OB-8

SCHEMATIC 1679A SHEET 2

OBERHEIM ELECTRONICS, INC.
ENGINEERING CHANGE ORDER

OB-8 VOICE BOARD 1682B SHEET 2

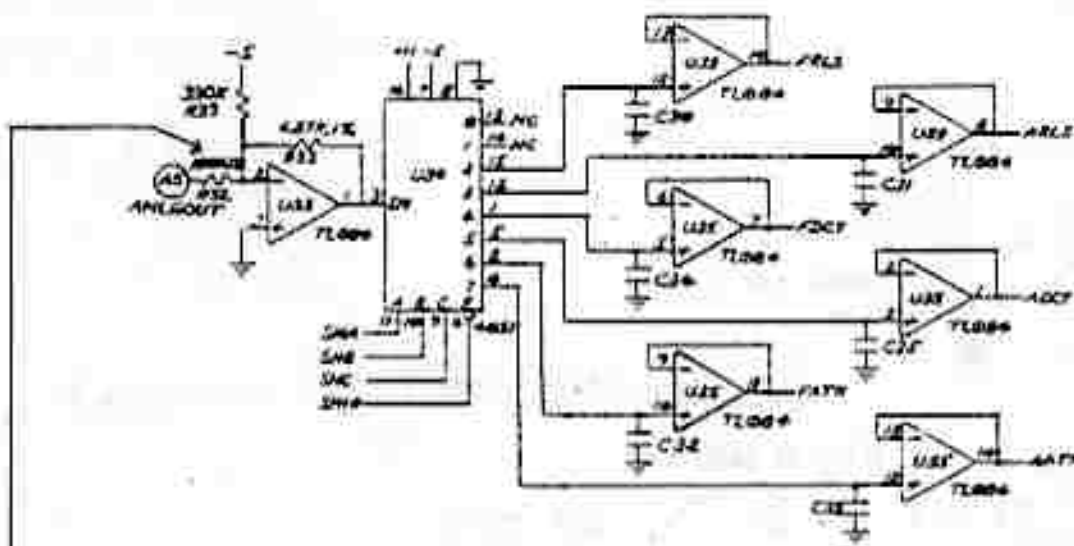
R32 100K 1% are 50Ω matched between Lower and upper Tray.

R32 on the Lower and upper tray are mounted after the two boards are screwed together.

— IMPROVES MATCHING OF TIMING BETWEEN ENVELOPES OF UPPER, AND LOWER TRAY.

1679 B - SHEET 1

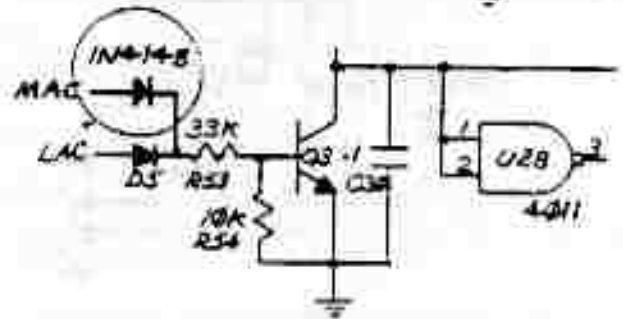
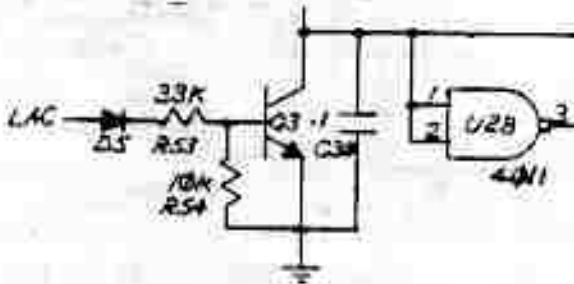
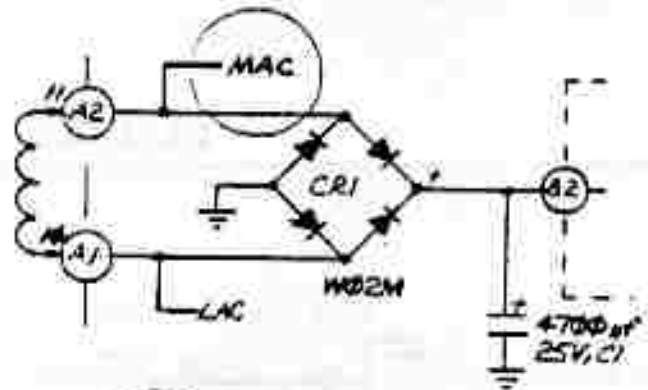
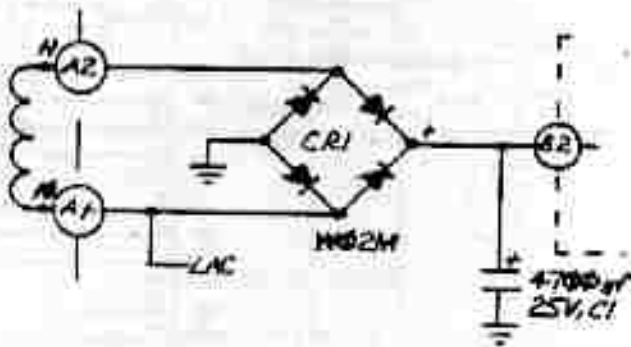
IMPROVE MARGIN OF "PUP" CIRCUIT TO INADVERTENT TURN-OFF, ESPECIALLY AT 50 KHz.

DRAWINGS AFFECTED
POWER SUPPLY

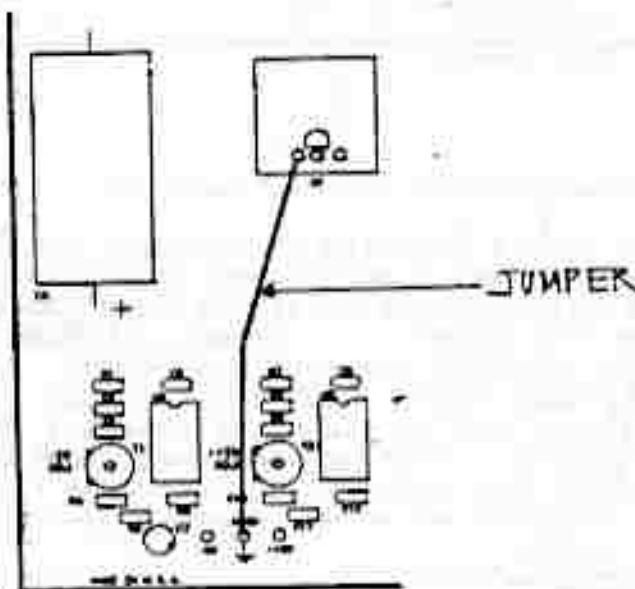
ADD A JUMPER BETWEEN PIN 1 OF THE -15 REGULATOR
7915 (GND) AND THE GROUND REFERENCE TEST POINT.
THE JUMPER MUST BE MADE OF A 18 AWG WIRE (.04 inch / 1 mm)
MINIMUM AND MUST BE SHORT.

TO REMOVE AC HUM ON AUDIO OUTPUT.

ECO # 419

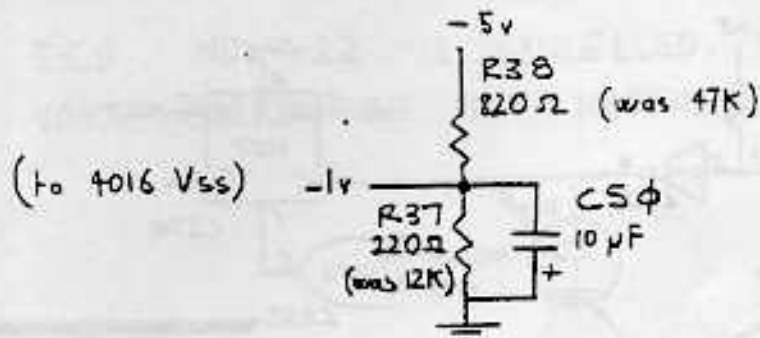
- change value of -1 divider on each voice board

- ALLOWS USE OF SIGNETICS' 4016 & IDENTIFIES COMPONENTS

OB-B PROCESSOR BOARD 1679B sheet 2 of 4

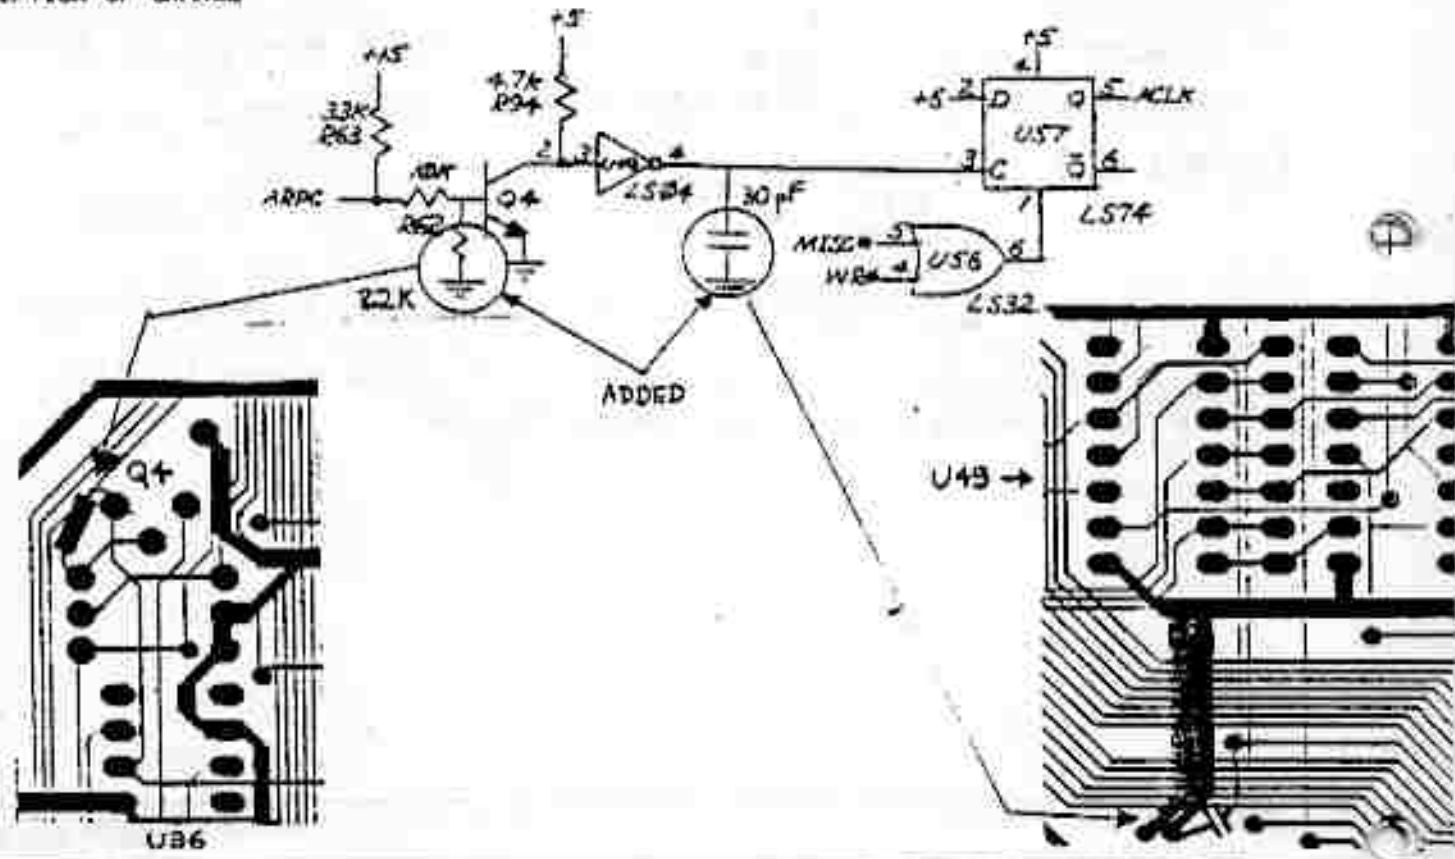
- AVOID MISSING PULSE ON ARPEGGIATOR EXTERNAL CLOCK

08-8 MOD CAN SCHEMATIC
SHEET 1 OF 1.

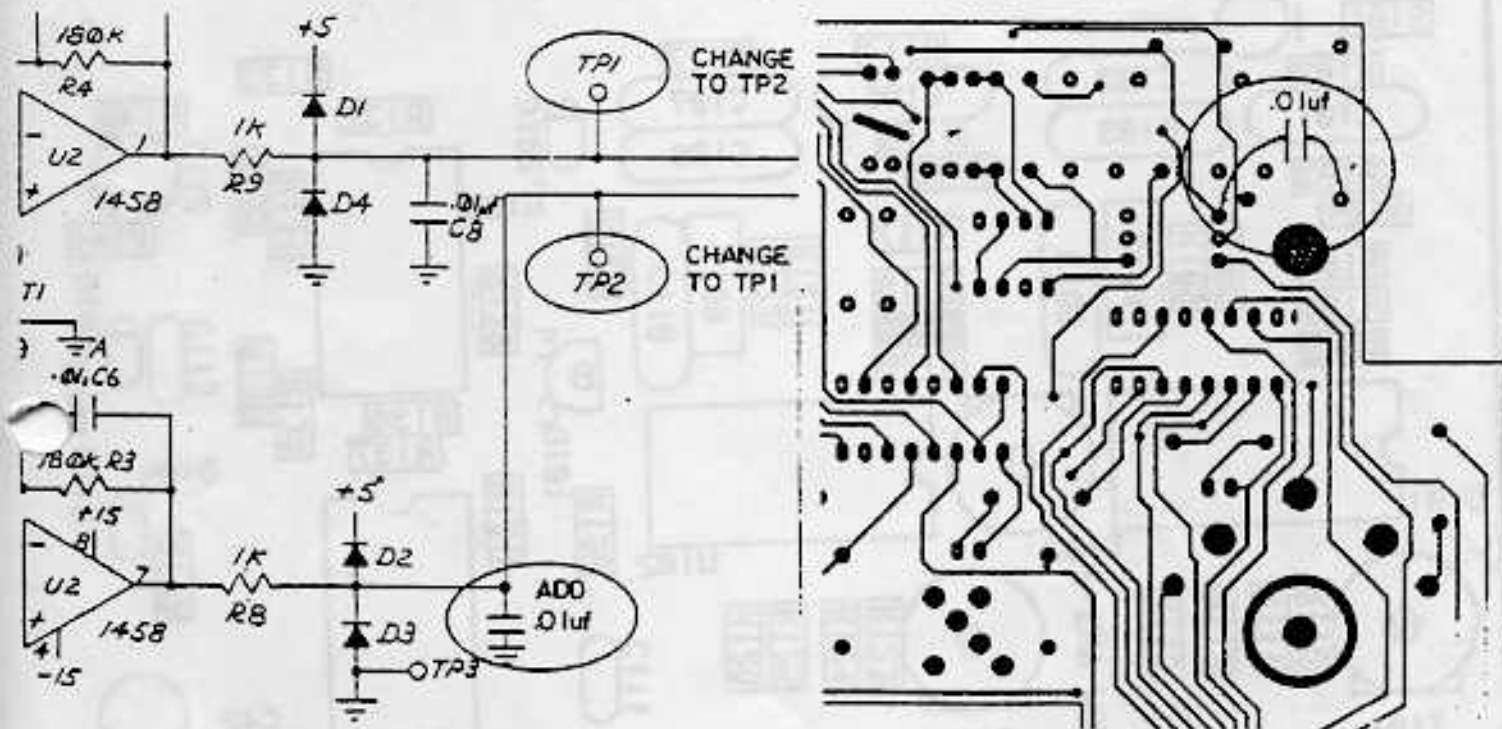
REMOVE NOISE MODULATION FROM
VIBRATO LEVER, AND CORRECT
SCHEMATIC.

1. CHANGE SCHEMATIC AS SHOWN.
2. ADD .01uf CAP (08.153004) FROM GROUND TO TEST POINT (T.P. 2) OF MOD CAN PCB ON 1666 SIDE OF BOARD.

DRAWINGS AFFECTED VOICE BOARD
SCHEMATIC 1682B SHEET 3 OF 3

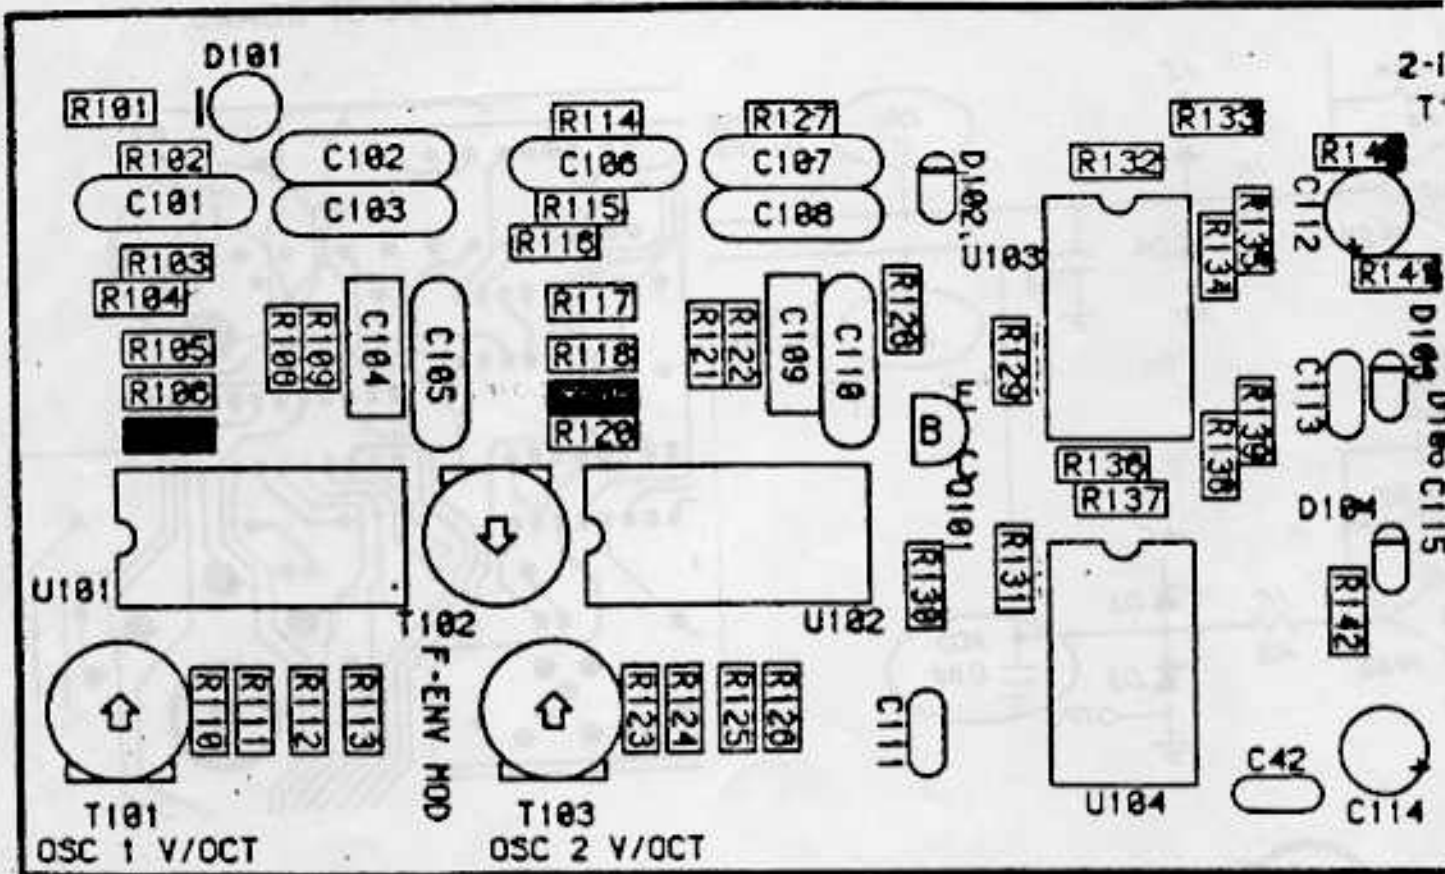
LOWER INITIAL FREQUENCY OF 3340
TO ACCOMMODATE A WIDER RANGE
OF CHARACTERISTIC VARIATIONS ON
THE 3340.

REPLACE RESISTOR RX07 AND RX19 (215K, 1%)
WITH 174K, 1% (OB#475520).
